Re: Sims Mesa Compressor Station New Mexico Oil Conservation Division Inspection Report, GW-146 NE/4, NE/4 Section 22, Township 30 North, Range 7 West, NMPM Rio Arriba County, NM

Val Verde Gas Gathering Company, L.P. is submitting this response to concerns noted at the abovereferenced facility in the July 28, 2009 New Mexico Oil Conservation Division Discharge Permit Approval Conditions for the Sims Mesa Compressor Station

Val Verde Gas Gathering L.P. Sims Mesa Compressor Station New Mexico Oil Conservation Division Inspection Report, GW-146

Sub Grade Tank Design

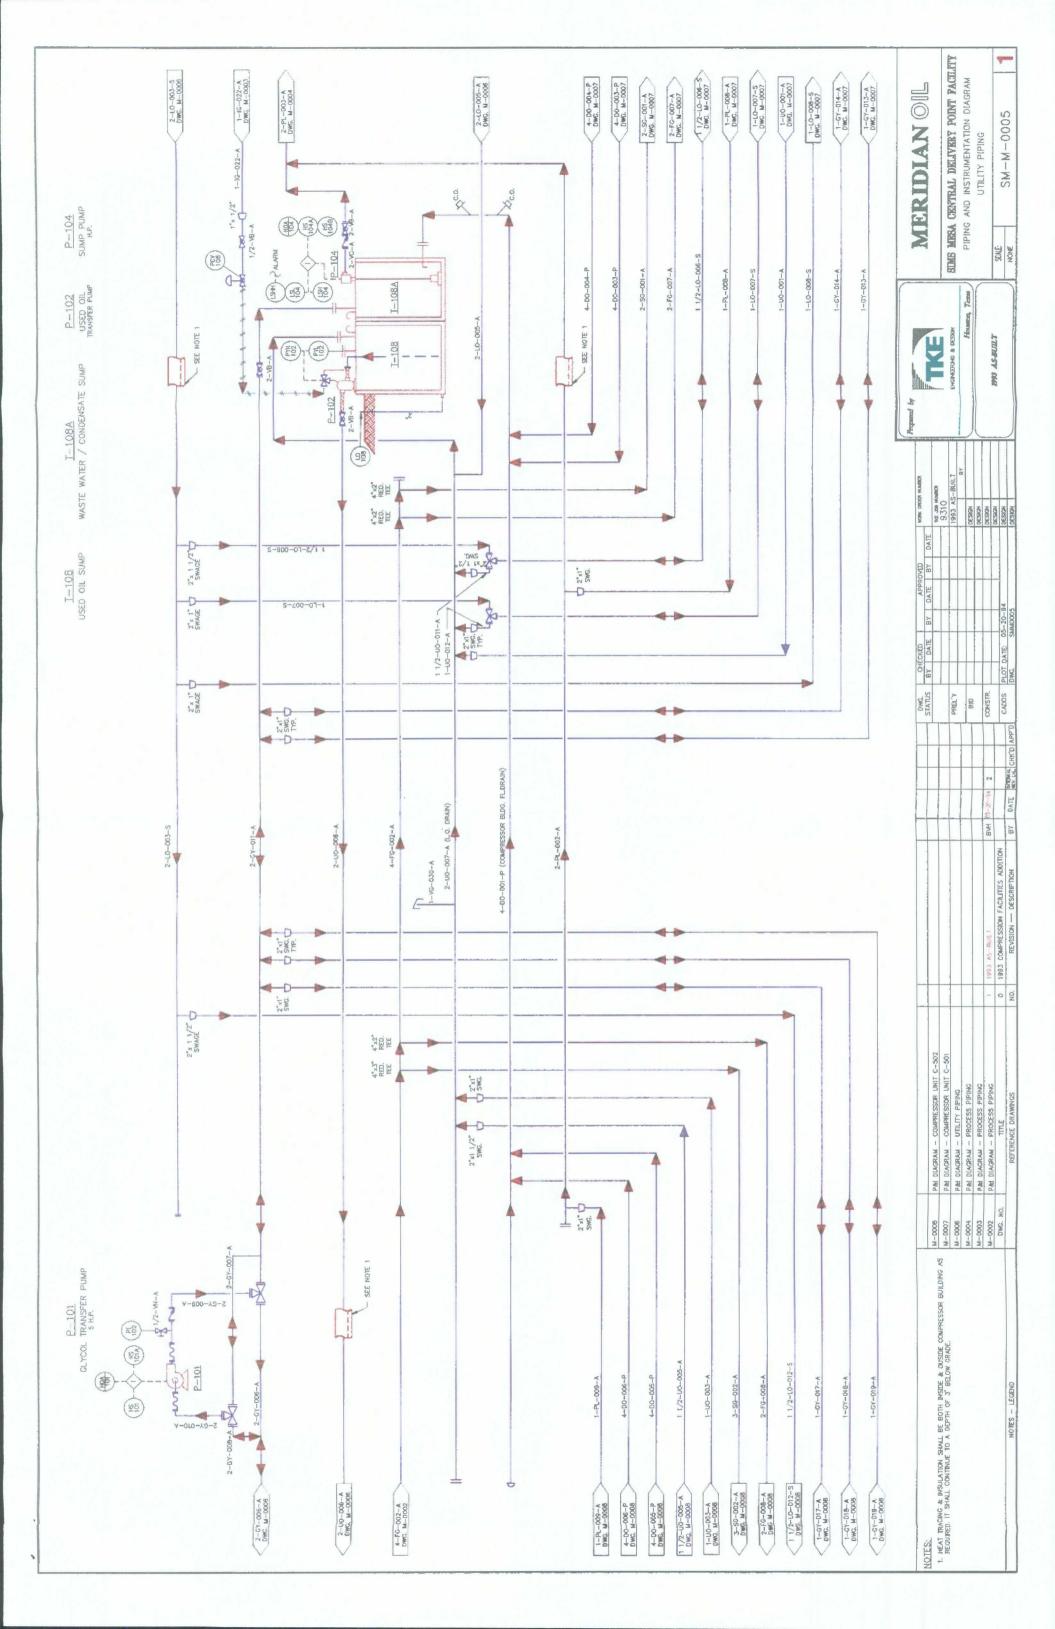
3. Photo 8 - 9: A below-grade tank is located behind the compressor building. It was not determined if the tank had a double walled leak detection system. Owner/operator is reminded that all below-grade tanks need to be inspected monthly.

Response: The below-grade tank located behind the compressor building includes a double-wall with a leak detection system. The system is inspected monthly. Please see attachment A which shows the construction specifications for this below-grade tank. Please see Attachment B which shows documentation of a recent inspection of tanks located at this facility.
